ANN ARBOR HISTORIC DISTRICT COMMISSION

Staff Report

ADDRESS: 403 W Liberty Street, Application Number HDC18-014

REPORT DATE: February 8, 2018

**4113 - SITE PLAN**

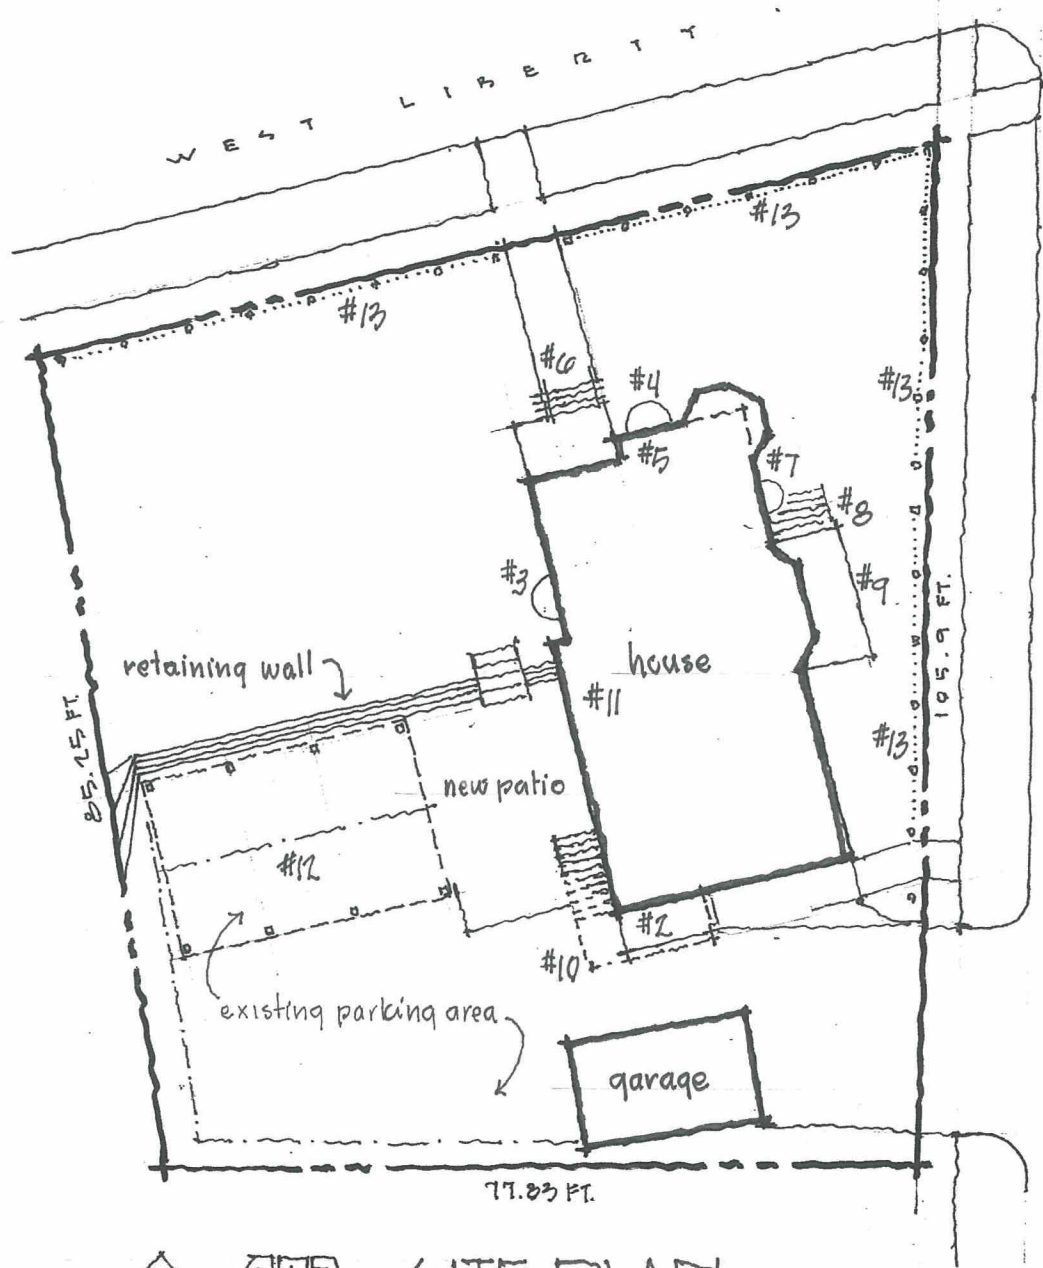
- 12) Construct a three car open carport in the rear yard auto court. (See site plan and elevations) Sidewalls to be open wood screening. Building set down low, so not visible from Liberty and hidden from Second St. by existing house and garage.

- A) Restore all of the existing original windows by a professional experienced in said restorations.
- B) Repaint the exterior wood work.
- C) Restore the relatively intact original interior.
- D) Enhance and improve the exterior landscaping and landscape features. Pave auto court in precast grass pavers to make a pervious green paved surface.

NE corner elevation from corner of Second Street (left) and West Liberty (right):

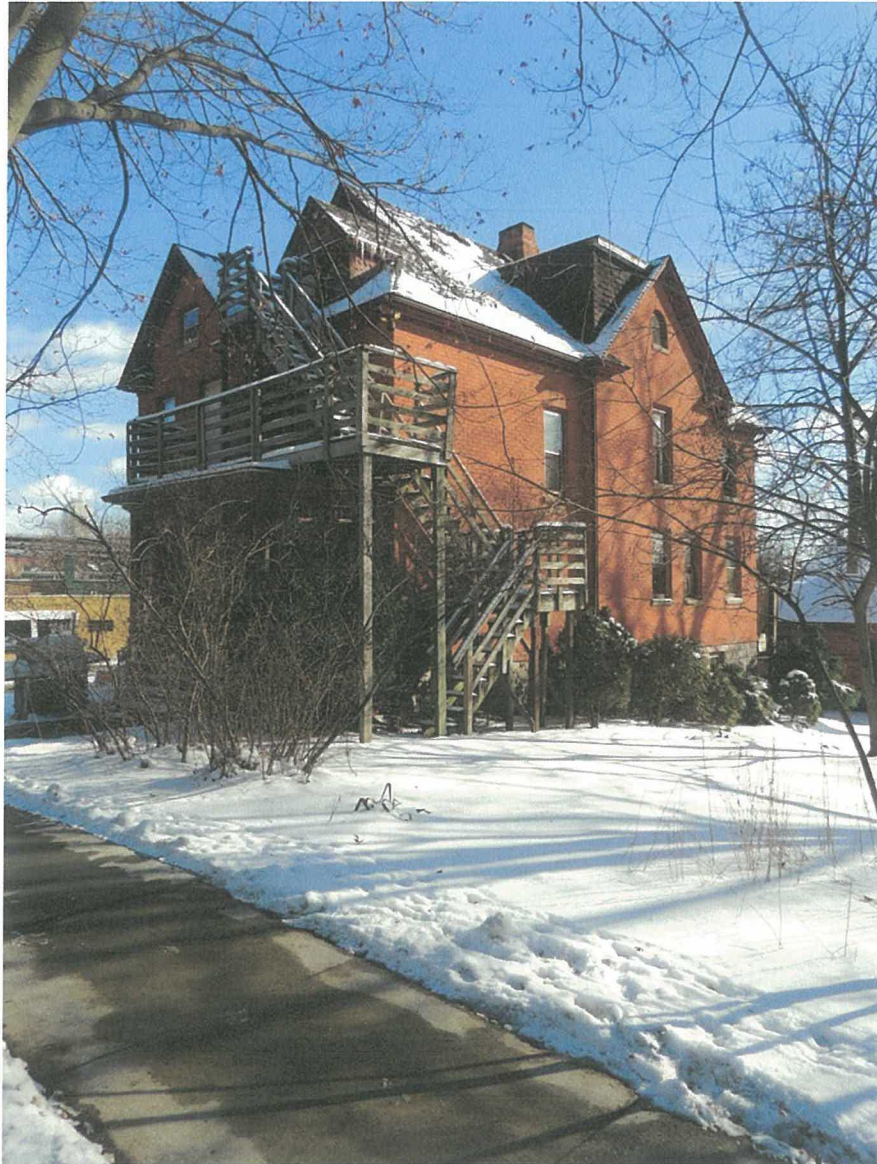
- #1 All fire escapes to be removed
- #4 Re-establish basement window at front next to bay
- #5 Re-establish 2nd floor window to match existing adjacent original units
- #6 Redo entry porch handrail to match east porch
- #7 Revise basement window adjacent to east porch steps to be egress window
- #8 Replace east porch and entry porch steps
- #13 Erect wrought iron fence along sidewalks both directions

NW corner elevation from West Liberty:

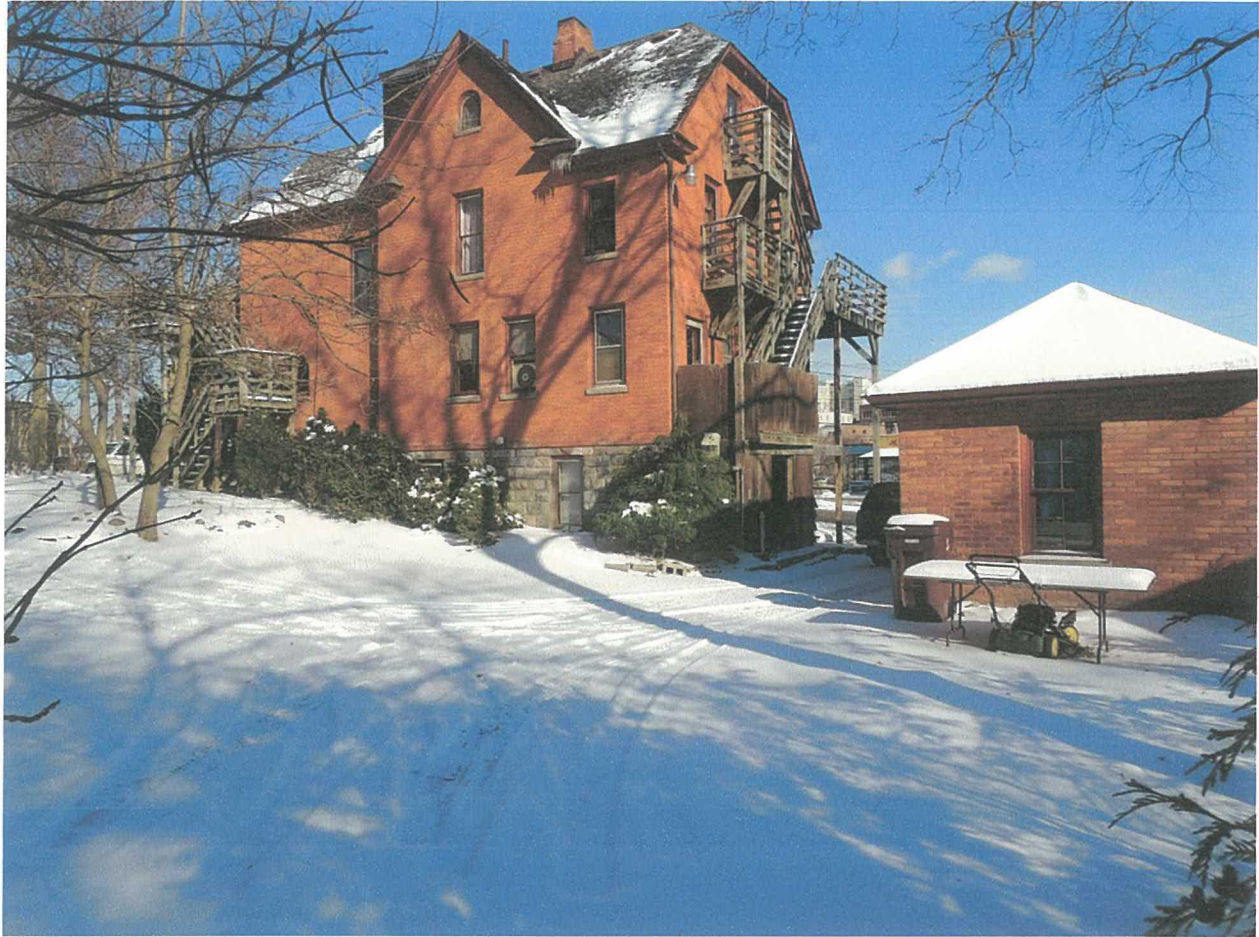
See NE corner elevation notes above plus;

- #3 Re-establish basement window open as egress window with area well (behind) yew bushes on west elevation
- #11 Re-work hump on roof to diminish its size, ad skylights into top and finish it to blend in more to roof

South elevation:

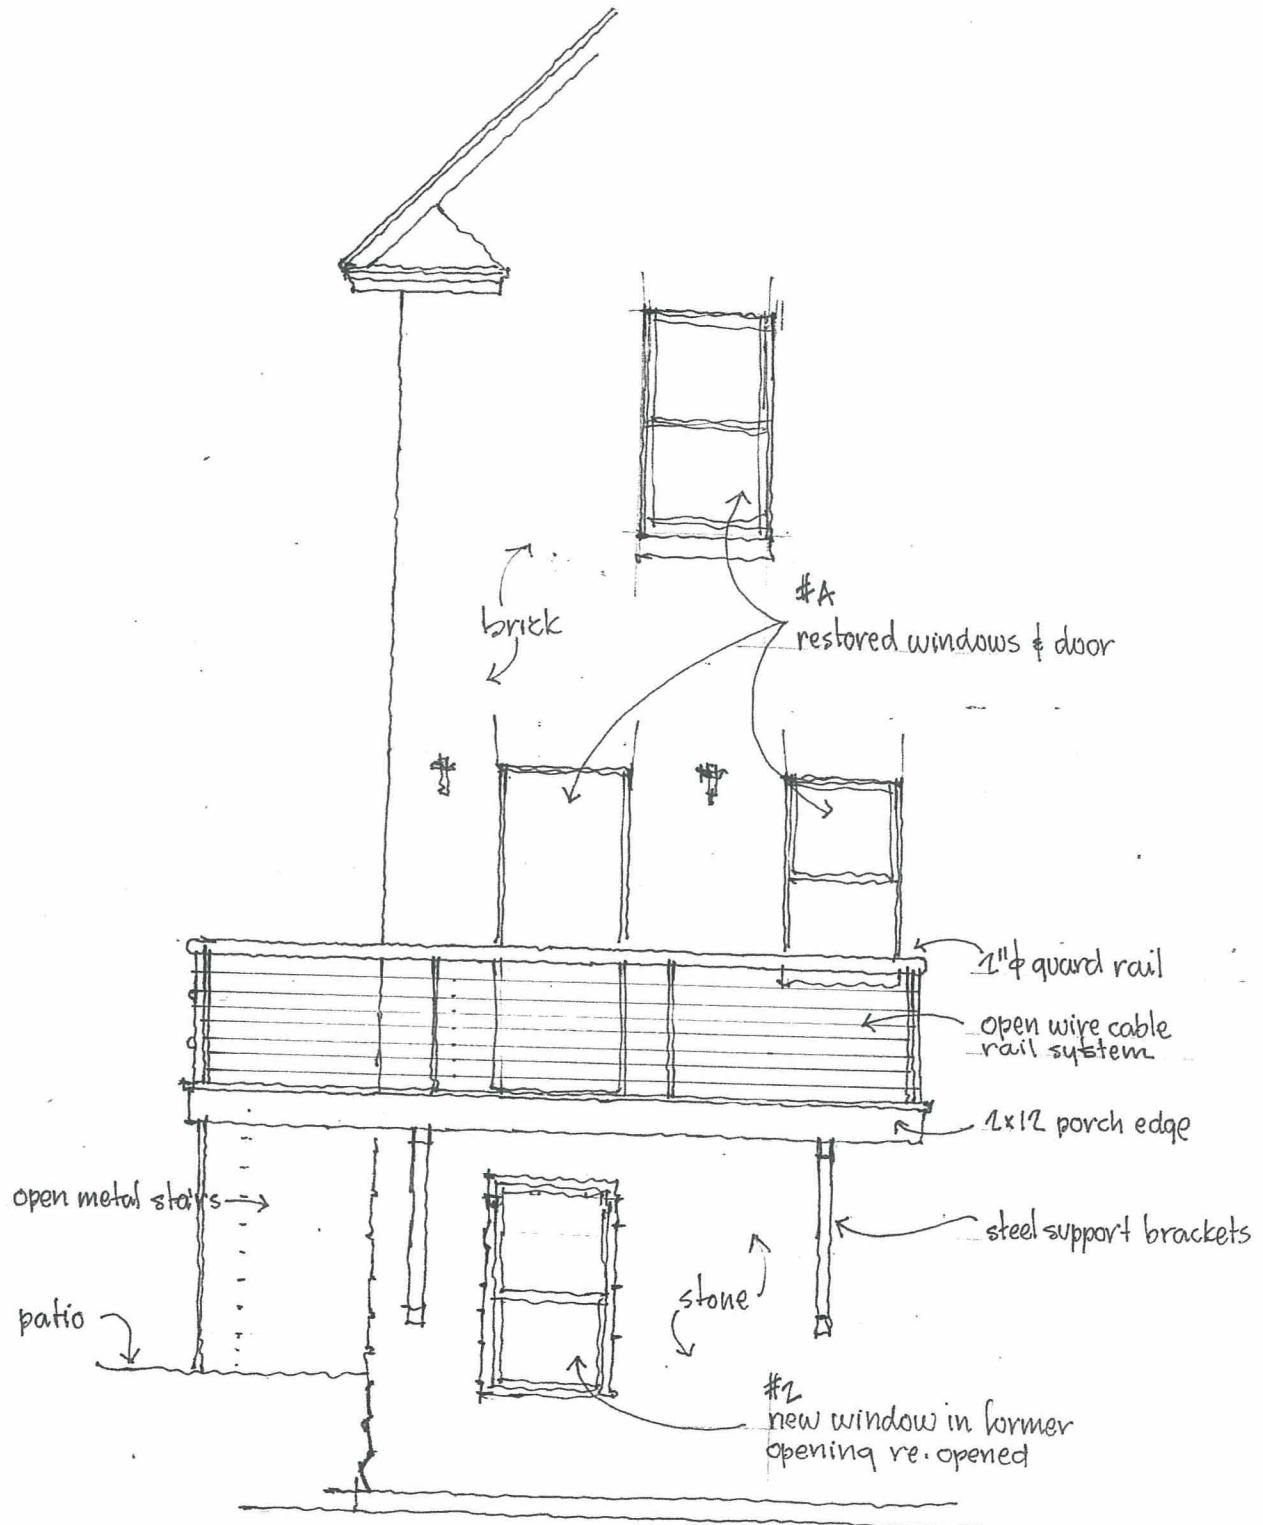
- #1 Remove fire escapes
- #2 Re-open south window opening, now infilled with stone, into new lower level apartment
- #10 Build new south porch off of second floor to replace original with steps leading off and around to west

413 NEW SOUTH FIRST FLOOR ENTRY PORCH #10

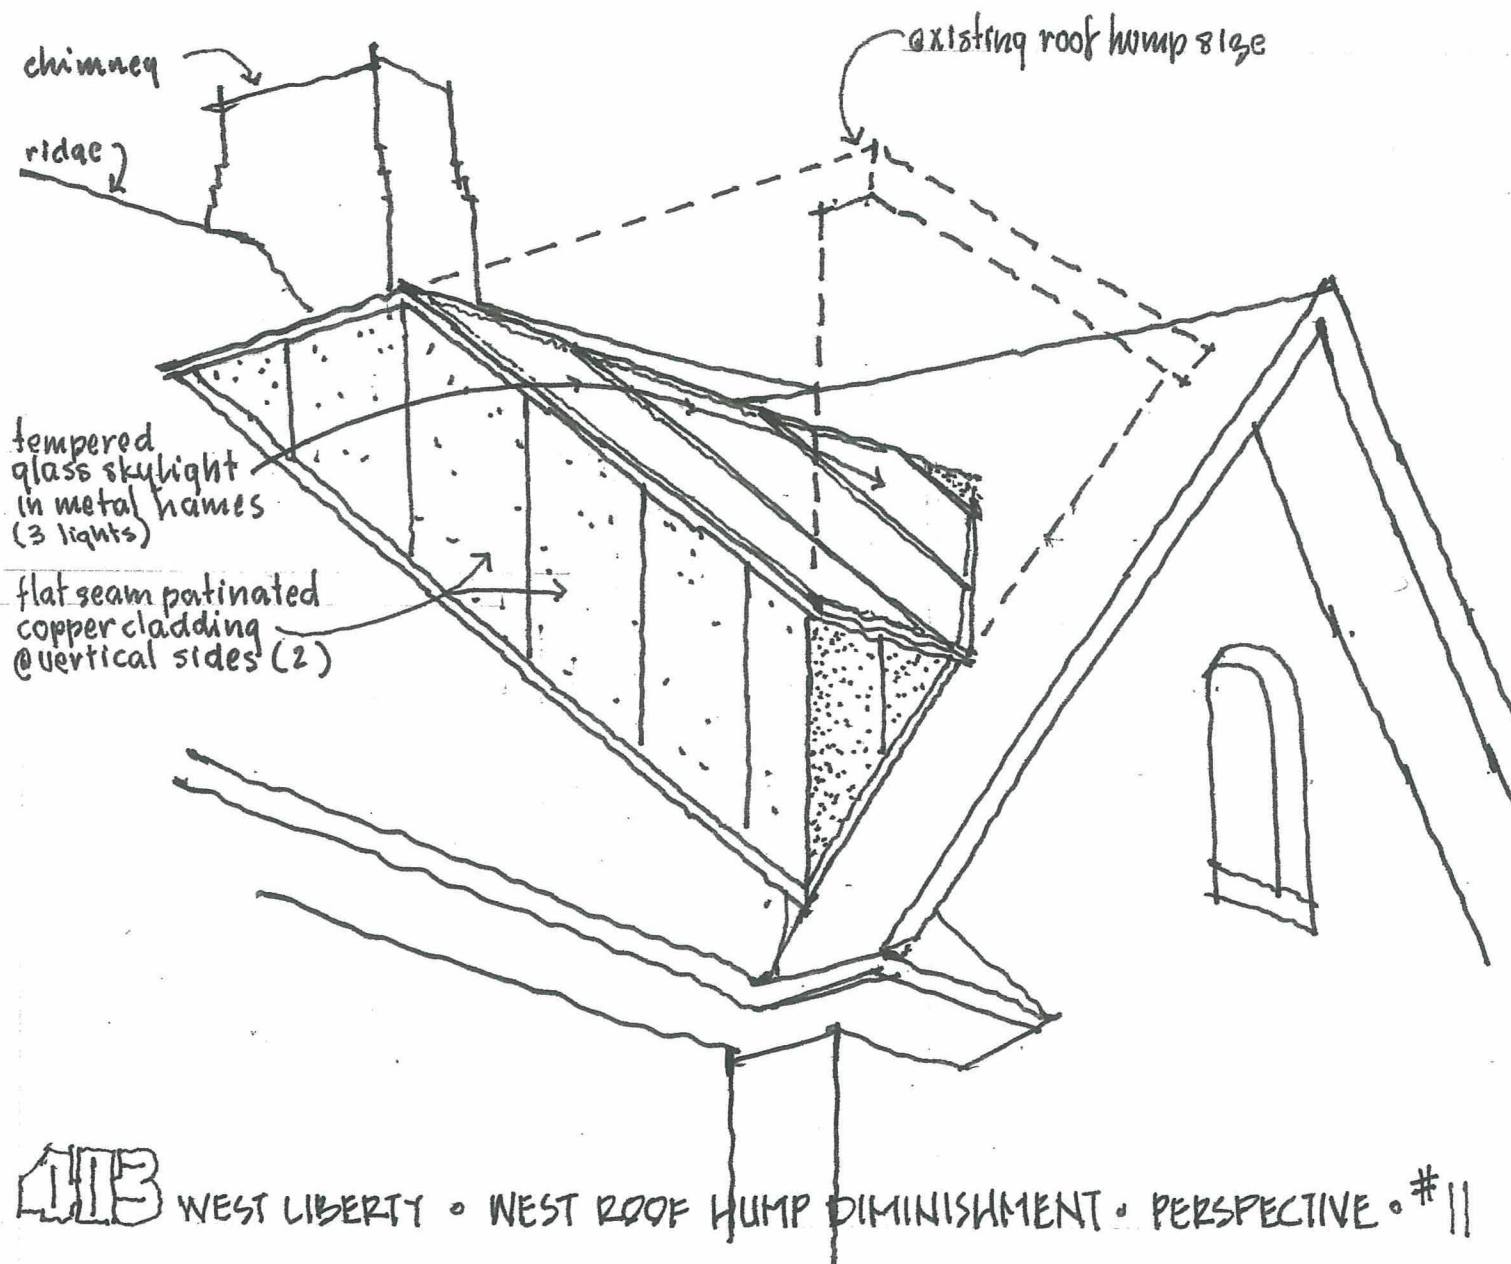
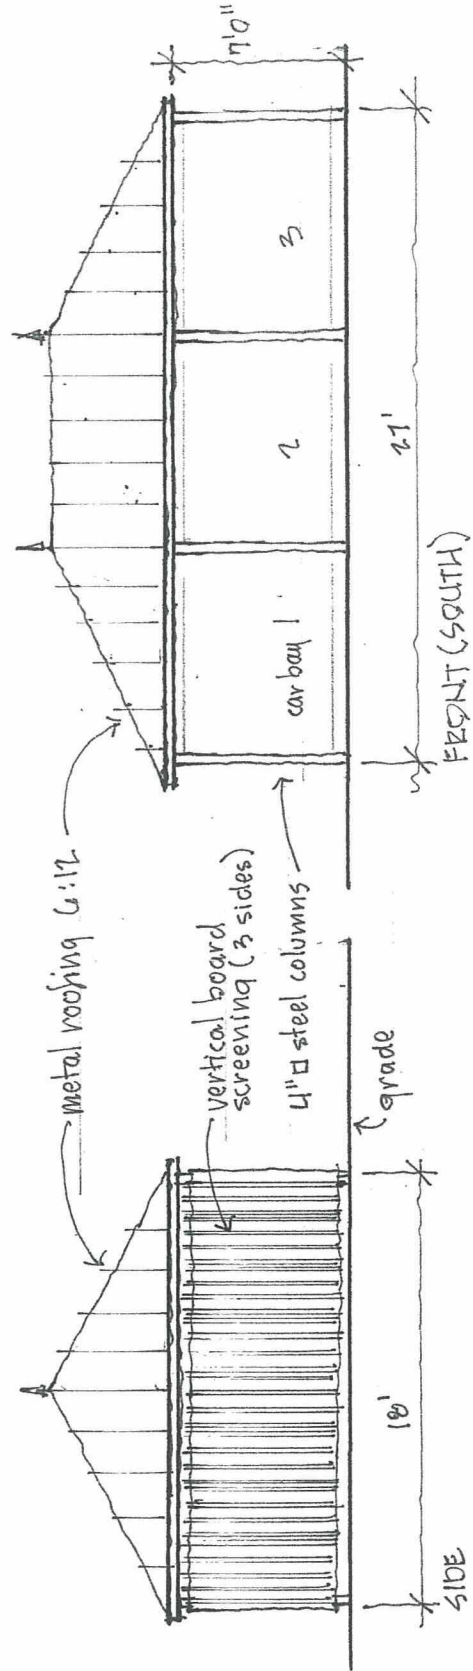
4. The new rear entry porch to the original kitchen, with metal stairs and a cable guardrail, is a modern and compatible design that has a minimalistic feel. It does not compete with or distract from the historic character of the house.

- #3 West basement window noted above to be re-opened and re-worked in size to make an egress window to an existing bedroom, including and in ground area well

- #2 Re-open south basement window presently infilled with stone

403 • SIDE ELEVATION • CARPORT @ 1/4"=1'-0" #12

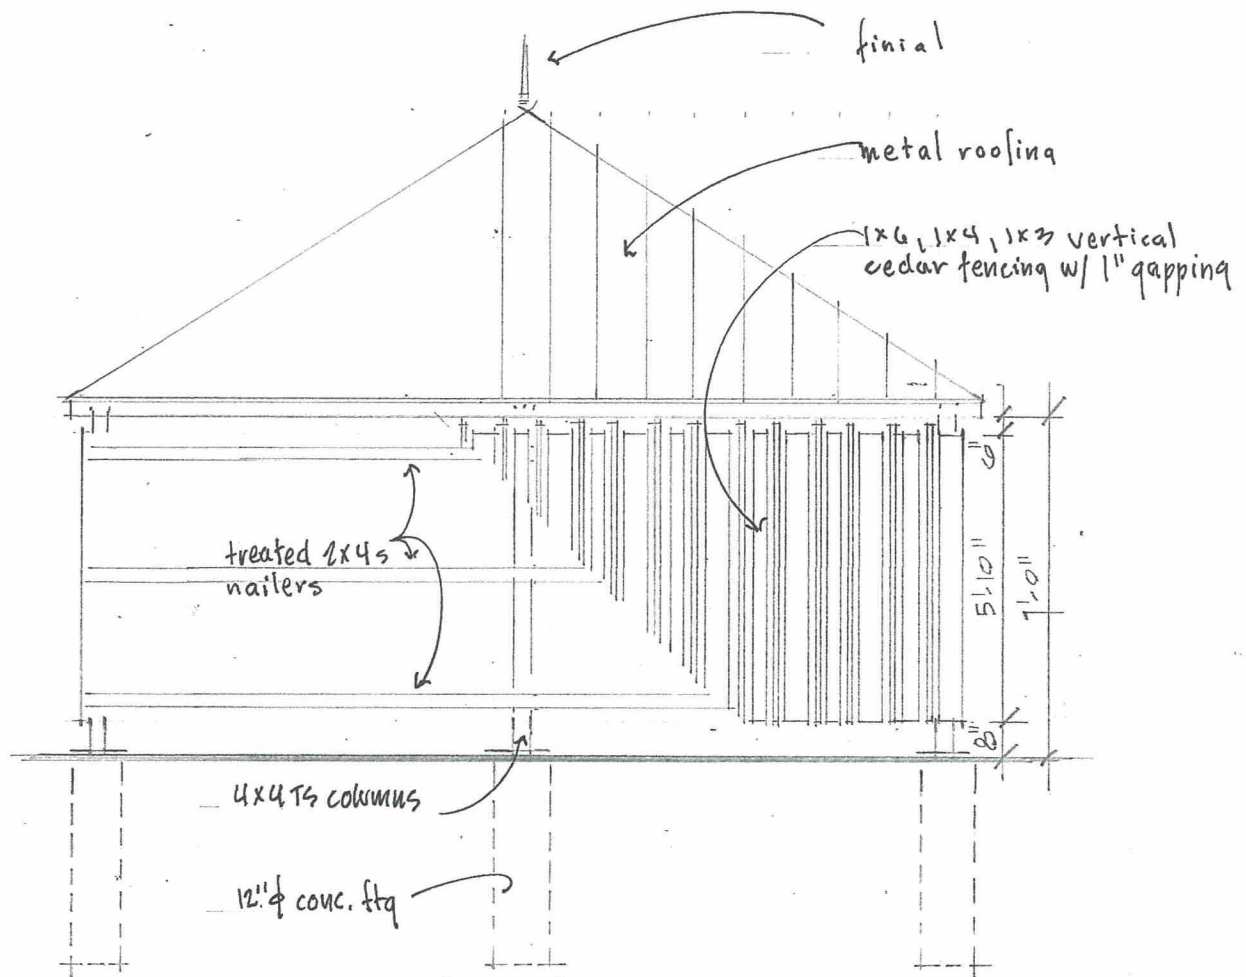
6. The carport is proposed in the same area currently used for parking, and would be serviced by the existing driveway off Second Street. It is more than 40 feet from West Liberty Street. A new 4' fieldstone retaining wall between the house and west property line would result in the carport setting lower than the grade of the yard at the street, which

would help minimize its modest 14' height. The hipped roof design also helps the carport appear smaller. The contributing historic brick one-car garage would remain. The courtyard area behind the carport would be converted from gravel to precast grass pavers. A 16'x24' bluestone patio is proposed between the carport and rear of the house.

THE CARPORT ELEVATIONS #12
